Re. Economic Development Queensland Outstanding Matters Response Letter for Reconfiguring a Lot application (DEV2025/1676) over land at 4745 – 4759 and 4761-4773 Mount Lindesay Highway, North Maclean.

1. Outstanding Matters Response

Item 1 – Biodiversity Values

Figure 1: Overall Layout Plan with overlay of impacted vegetation and 50m buffer

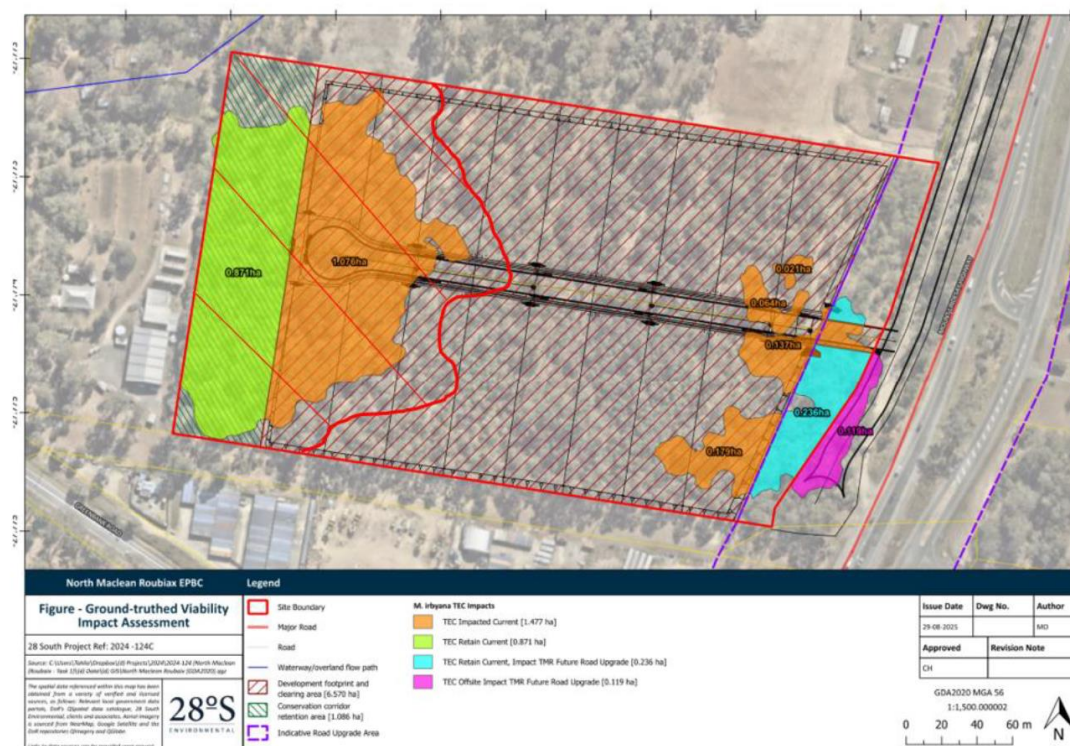
Provide amended subdivision plans, including a change to the cul-de-sac location in the Industrial Access Street, removing lots at the western end of the site identified as containing ground-truthed impacted vegetation plus a 50m protection buffer.

The Outstanding Matters Request seeks amended subdivision plans that relocate the cul-de-sac within the Industrial Access Street and remove proposed lots at the western end of the Site to accommodate ground-truthed impacted vegetation and a 50 metre (m) protection buffer.

The Applicant has carefully considered EDQ's requested retention area and associated subdivision amendments. However, the Applicant does not consider the extent of the proposed retention area identified by EDQ to be a reasonable or necessary development outcome having regard to the Site's planning context, ecological characteristics and surrounding land uses.

In response to previous EDQ comments, the development layout was amended to incorporate a 50m vegetation buffer along the western boundary of the Site. Included within this latest response letter is an updated impact assessment figure (**Figure 1**) that contemporises impact areas relative to the updated development layout (**Attachment 2**). This buffer retains approximately 1.187 ha of land, including approximately 0.941 ha of ground-truthed Category B vegetation comprising Regional Ecosystem 12.3.18 and the Swamp Tea-tree (*Melaleuca irbyana*) Threatened Ecological Community. The buffer area avoids both direct and indirect impacts and excludes stormwater and development infrastructure.

The Applicant does not consider that the additional retention area sought by EDQ would provide a meaningful ecological or connectivity outcome beyond that already achieved through the incorporated 50m buffer that connects to the retained 50m vegetation buffer to the north.

Notwithstanding the above, the Applicant has reviewed the subdivision layout and reproduced the development footprint to maintain the approved development intent of creating 17 industrial lots while maintaining protection of retained vegetation (refer **Attachment 2**).

The revised layout retains the 50m vegetation buffer along the western boundary and proposes that the retained vegetation areas associated with Lots 1 and 9 be permanently protected through the establishment of a private covenant. The covenant will ensure the ongoing protection and management of the retained vegetation through the greatest legal means practical. The covenant will be applied to the vegetation with the highest ecological value on the Site with the intent to retain this vegetation in perpetuity.
